DAVIS-BESSE NUCLEAR POWER STATION UNIT NO. 1
THE TOLEDO EDISON COMPANY

INSERVICE INSPECTION DIAGRAM STEAM GENERATOR SECONDARY SYSTEM

ISID2-007A 5

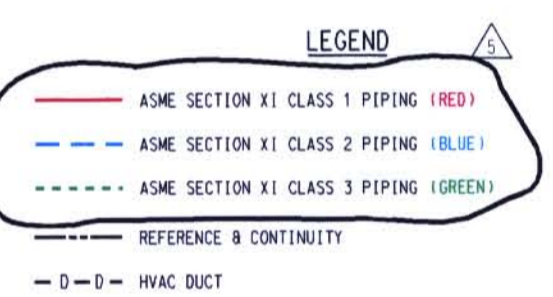
INFO. NOTE:
(REMOVE AT NEXT UPDATE)
REVISION CHANGE IN THE CLOUDED
AREA WAS FOR COLORIZING THE
LINE CLASS CODES

INFO. NOTE:
(REMOVE AT NEXT UPDATE)
REVISION CHANGE IN THE CLOUDED
AREA WAS FOR COLORIZING THE
LINE CLASS CODES
